Access Compliance Report

Public Rights-of-Way

(Curb Ramps)

Intersection ID: 30323	Main Street: SHINKANSEN_DR	Cross Street: STOURBRIDGE_LION_DR	Location: S
ADA ID: 1788E9B85CC8	Ramp Type: PerpDiag	Initial Pass/Fail: Fail	Overall Compliance: No
Severity Score: 8.75			
Codes/Mitigation Info/Possible Solution		Field Measurements/Component Compliance

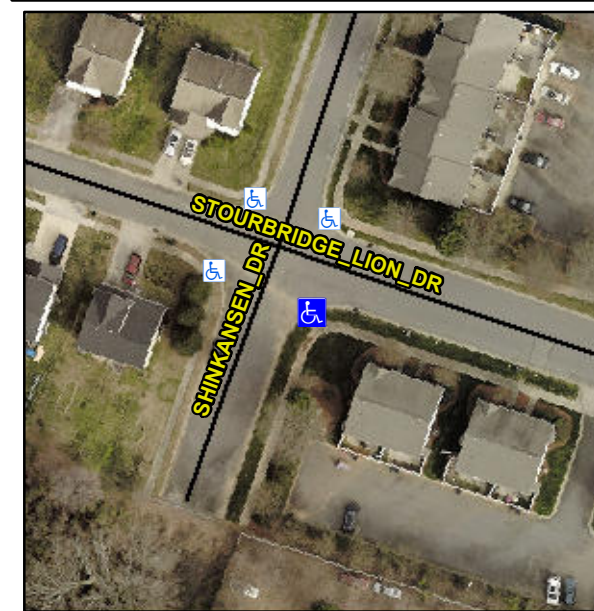
Not Found, R304.5.1

Compliance	Description	Data	Compliance	Description	Data
N/A	Ramp Length (in)	72.5	Yes	Ramp Slope (%)	5.8
No	Ramp Width (in)	42.5	Yes	Ramp XSlope (%)	0.8
N/A	Flare Type LT	N/A	N/A	Flare Type RT	N/A
N/A	Flare Slope LT (%)	N/A	N/A	Flare Slope RT (%)	N/A
N/A	Flare Traversable LT?	N/A	N/A	Flare Traversable RT?	N/A
N/A	Landing Length (in)	N/A	N/A	DWS Provided?	N/A
N/A	Landing Width (in)	N/A	N/A	DWS Contrast?	N/A
N/A	Landing Slope (%)	N/A	N/A	DWS Length (in)	N/A
N/A	Landing X Slope (%)	N/A	N/A	DWS Full Width?	N/A
N/A	Landing Curb? (Y/N)	N/A	N/A	DWS Offset (in)	N/A
N/A	Shared Landing?	N/A			
N/A	Gutter Ponding?	N/A	N/A	Gutter Slope (%)	N/A
N/A	Gutter Lip Ht (in)	N/A	N/A	Gutter X Slope (%)	N/A
N/A	Painted X Walk1?	No	N/A	Painted X Walk2?	No
	X Walk 1 Direction	To E		X Walk 2 Direction	To W
N/A	X Walk 1 Width (in)	N/A	N/A	X Walk 2 Width (in)	N/A
	X Walk 1 Slope (%)	0.7		X Walk 2 Slope (%)	0.6
	X Walk 1 X Slope (%)	1.7		X Walk 2 X Slope (%)	0.0

Remove & Replace Curb Ramp With Two New Directional Ramps or Equivalent.
